RE: GRADING AND DRAINAGE PLAN FOR LONG JOHN SILVER'S RESTAURANT,
SUBMITTED OCTOBER 16, 1989, FOR INFORMATION (MODIFICATION TO
THE APPROVED PLAN DATED MARCH 3, 1989) (G-21/D7A)

GRADING & DRAINAGE PLAN

LONGJOHN SILVERS RESTAURANT

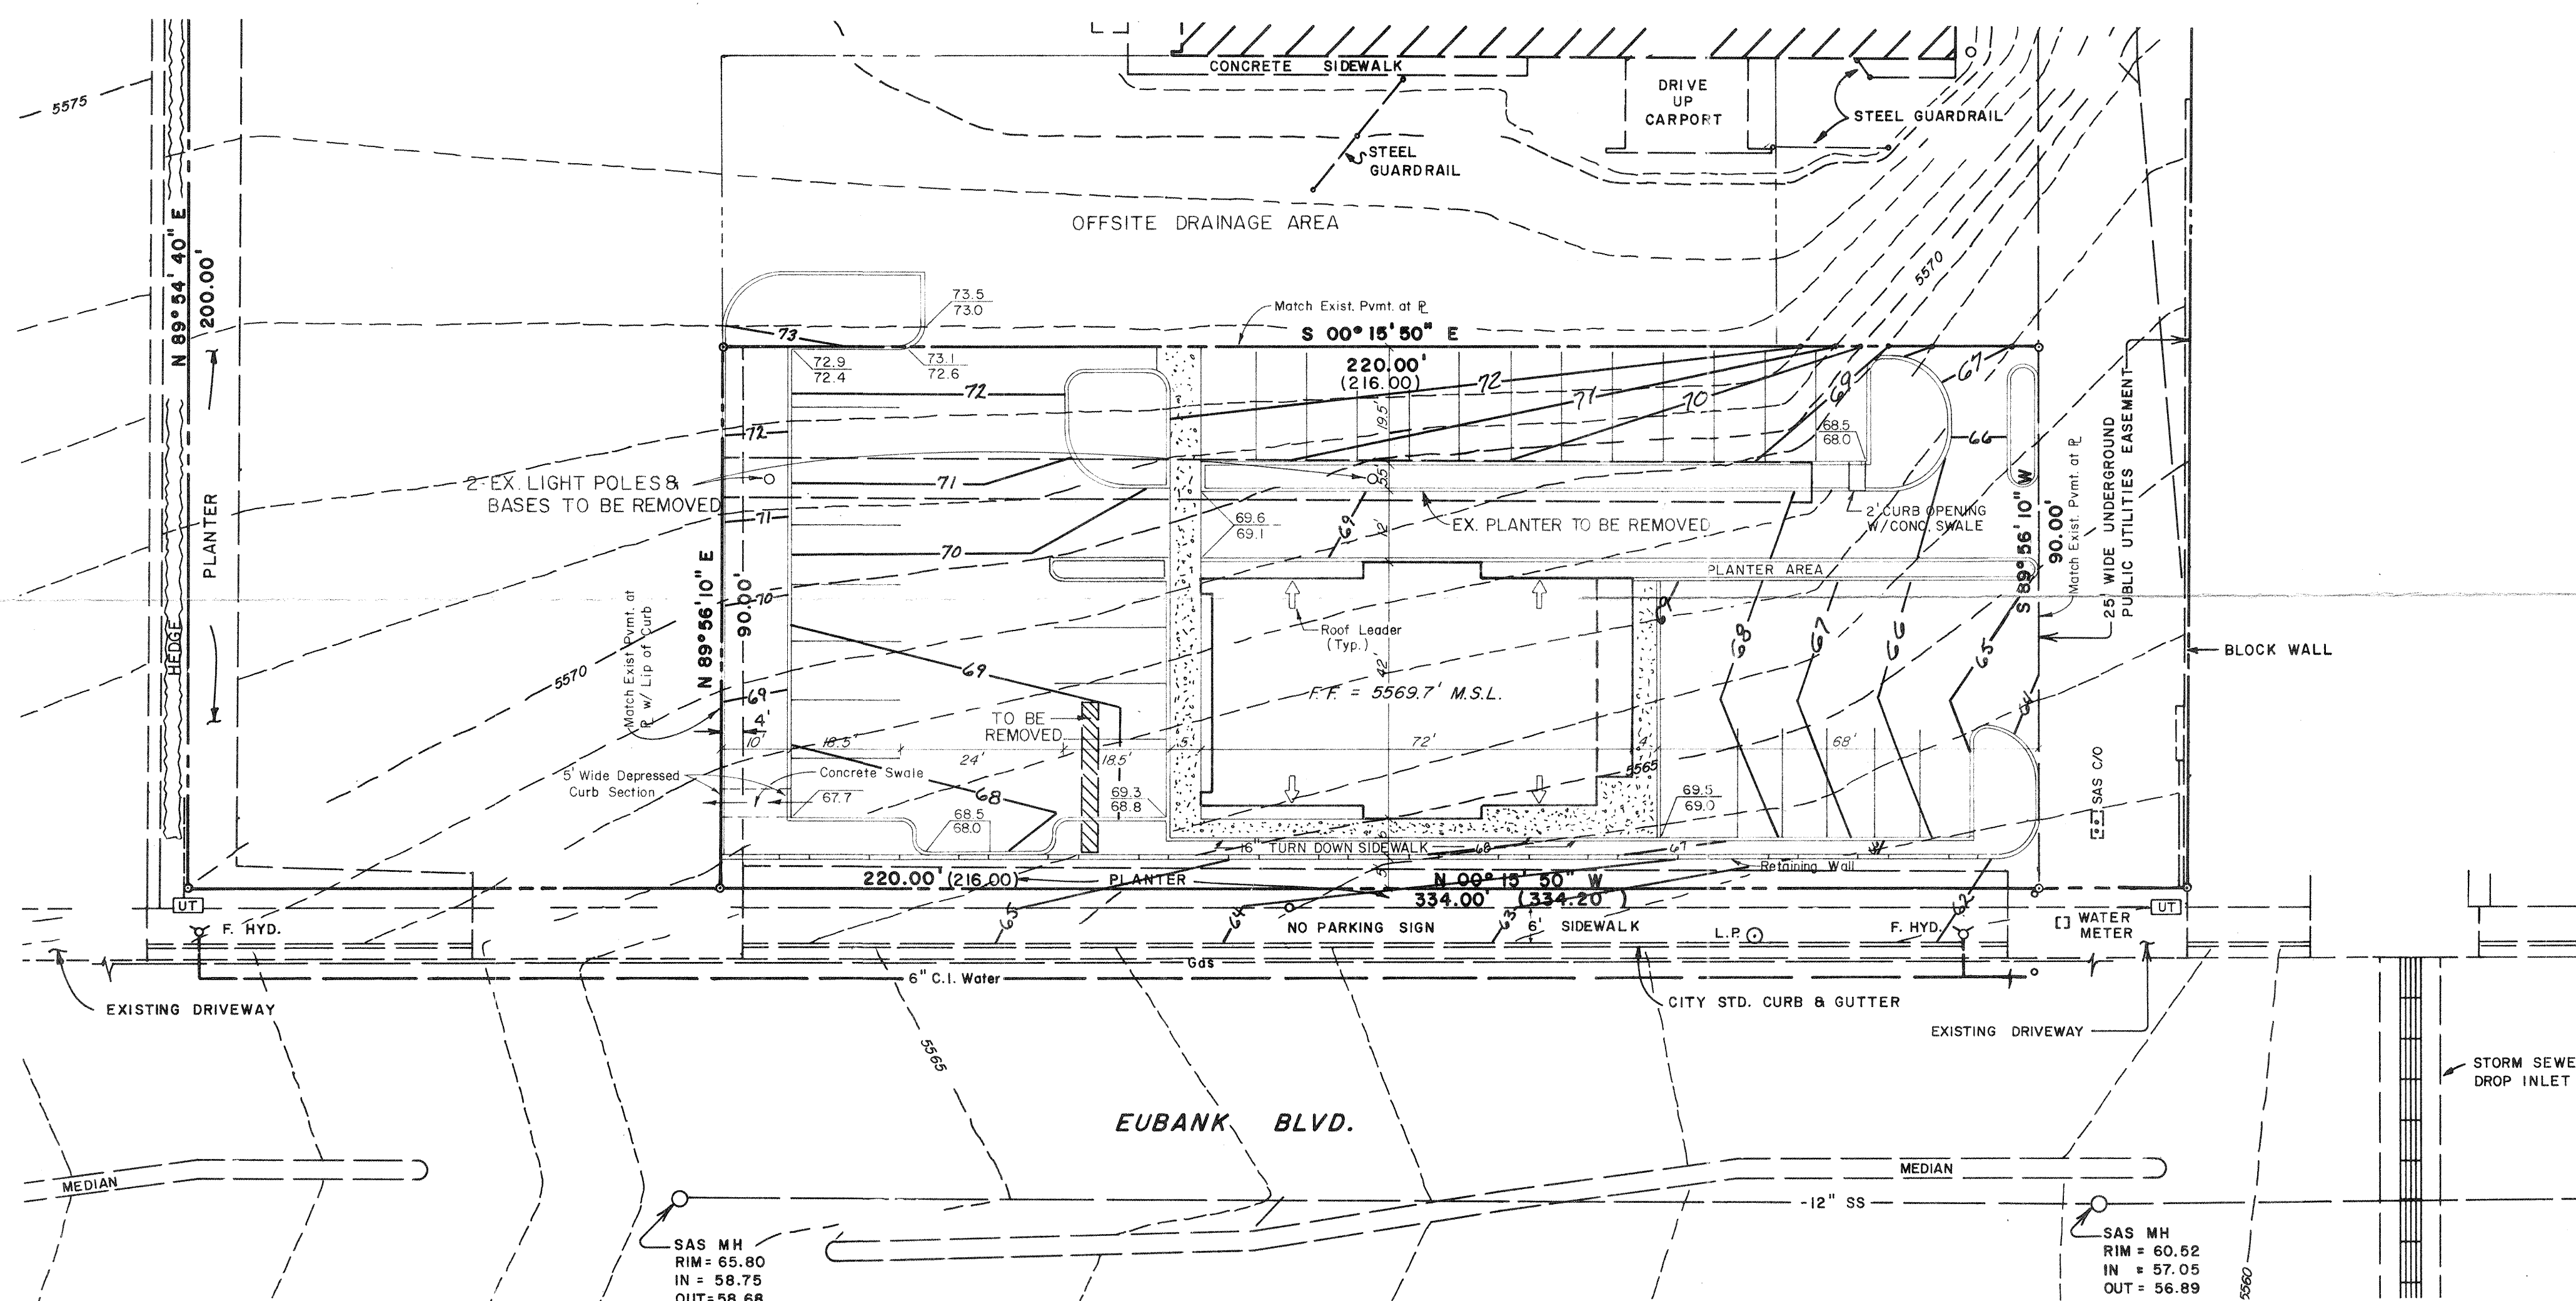
Your submittal, referred to above, with your engineer's stamp dated October 10, 1989, is approved for Building Permit sign-off by the Hydrology Section.

This drawing should replace the previous drawing (your stamp dated 3/3/89) in the construction sets routed for sign-off. This drawing will also stand as the document from which the final inspection by Hydrology for sign-off of the Certificate of Occupancy is made.
